Point Beach Nuclear Plant, Units 1 and 2
Dockets 50-266 and 50-301
Renewed License Nos. DPR-24 and DPR-27

Response to Request for Additional Information
License Amendment Request 247
Spent Fuel Pool Storage Criticality Control

RESPONSE TO REQUEST FOR ADDITIONAL INFORMATION LICENSE AMENDMENT REQUEST 247 SPENT FUEL POOL STORAGE CRITICALITY CONTROL

Figure 1 – Calculated k_{eff} versus $H/^{235}U$

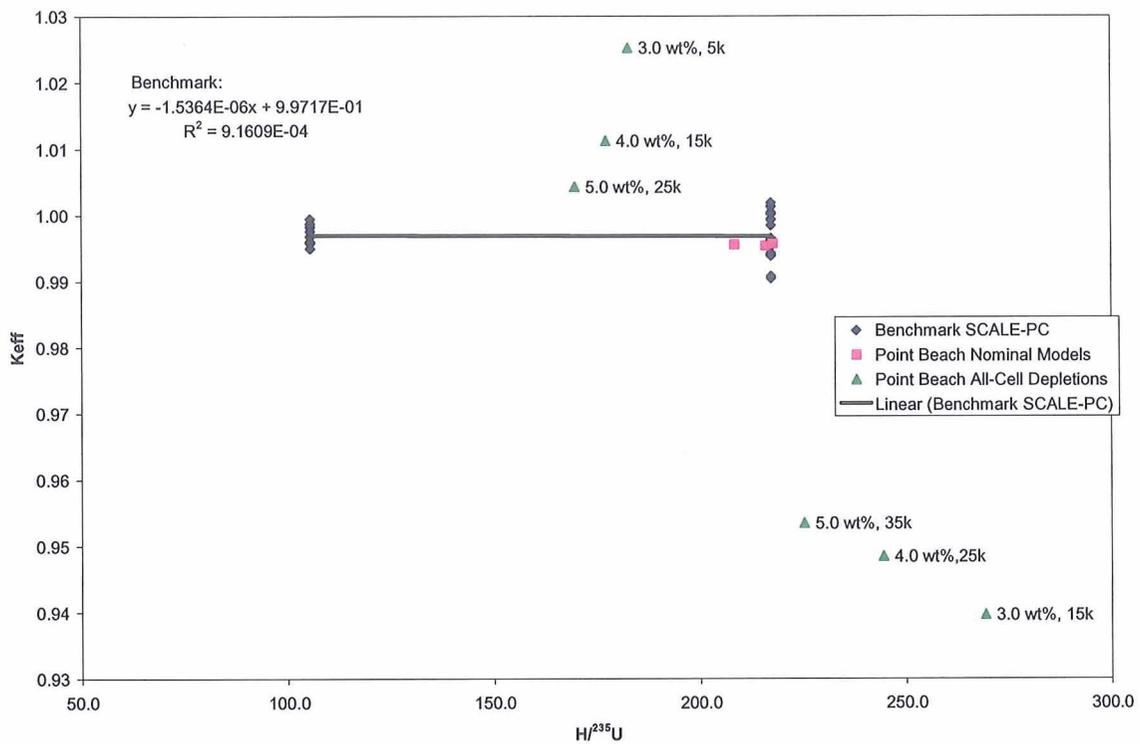
- a) *Table 1 of Request for Additional Information (RAI) 1 response does not include any spectral parameters (e.g., energy of the average lethargy causing fission, hydrogen to uranium atomic ratio (H/U)) to show how the validation is applicable to the Point Beach analysis. Figure 1 of RAI 1 response provides the H/U range for the validation but does not show how it compares to the Point Beach analysis. What are the H/U values for the system analyzed for Point Beach?*
- b) *Figure 1 shows a large range of H/U that is not supported by benchmarks. How is this justified?*
- c) *How did you conclude that the Figure 1 "data is well distributed and no trend is apparent as a function of H/²³⁵U?" Did you use any quantitative methods such as the regression analysis?*

Table 1 and Figure 1 show the calculated SCALE-PC neutron multiplication factors (k_{eff}) versus $\text{H}/^{235}\text{U}$ for the benchmark experiments, the nominal model for each of the PBNP configurations, and the All-Cell depletions surrounding the calculated burnup limit for 3.0, 4.0, and 5.0 wt%. The k_{eff} values shown for the PBNP analysis include the Total Biases and Uncertainties term for each configuration. The benchmark $\text{H}/^{235}\text{U}$ ratios have been recalculated to be consistent with the calculation of $\text{H}/^{235}\text{U}$ for the PBNP models. SCALE Version 5.1 k_{eff} values are also shown in Table 1 because this version of the code is used to support several of the RAI responses. SCALE Version 5.1 use for k_{eff} calculations is always indicated, except for Question 4 of the May 22, 2009 letter.

The conclusion that the data in Figure 1 of cover letter Reference (5), was well distributed and no trend was apparent was reached by examining the figure; no quantitative methods were used. Figures 1 and 2 of this document include linear fits of the benchmark data. The equation and R^2 value of each linear fit is included on the figure. The R^2 value is the coefficient of determination and measures the proportion of variation that is explained by the fit. An R^2 value of 1.0 would indicate a perfect fit. Both R^2 values are much less than 0.5 indicating that there is no trend in the data.
